387-112100-003

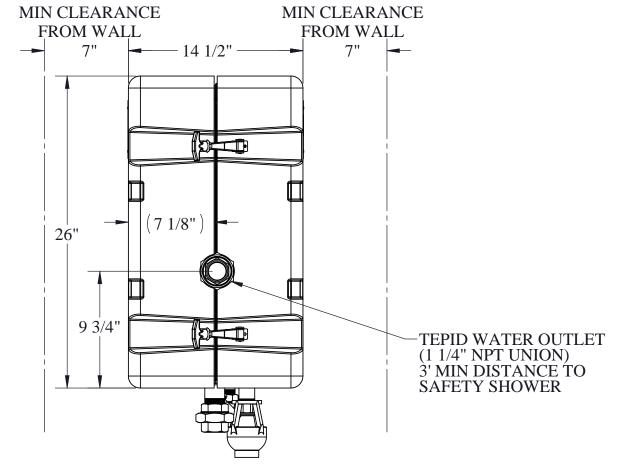
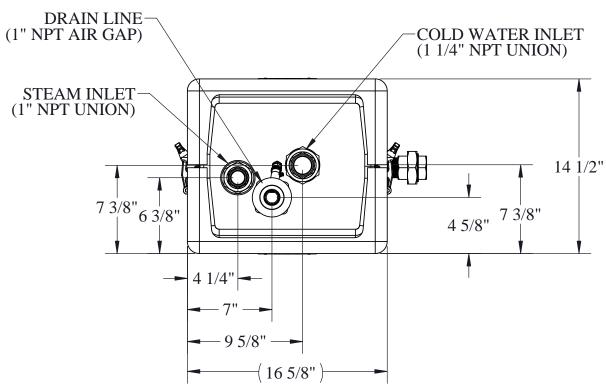
F	٠.	1027	ADDED AIR GAP FITTING TO CONDENSATE DRAIN AND REROUTED V6 DRAIN LINE					EWF	BCR	8/30/2018		
F	(4)	978	CHANGED ALL LITERATURE AND MARKINGS FROM HAWS TO THERMOMEGATECH						BCR	R 3/28/2018		
D	2	919C	CHANGED V-1 MIXING TEE FROM MACHINED ASSEMBLY (357-TOMOUTLET, 03-183) TO A CASTING (03-380). CHANGED PMHS (95-153) TO SHCS (95-020) ENCLOSURE STRAP					EWF	BCR	8/31/2017		
D	1	919B	CHANGED COLD WATE MACHINED PARTS (03-38 PARTS (03-38	177, 0. 2, 03-	3-178) 384).	TO CA	ST	EWF	BCR	8/9/	2017	
Ι)	919A	CHANGED HOT WATER OUTLET TEE FROM MACHINED PARTS (03-177, 03-179, 03-180) TO					EWF	BCR	6/22/2017		
RE	EV	ECN#	DESCRIP	SCRIPTION				BY	CHK	DATE		
		•	ThermOmegaTech® 353 lyyland Road, Warminster, PA 18974-2205 USA ThermOmegaTech.com • 215-674-9992 • 1-877-379-8258	ISO 9001 CERTIFIED	SHEET 1 OF 4 TITLE:	DWN BY EWF	CHK JPC O-MIX		CALE 1:8 ION GE	REV F N 3 (BP	DATE 3/23/2016 HE) SS
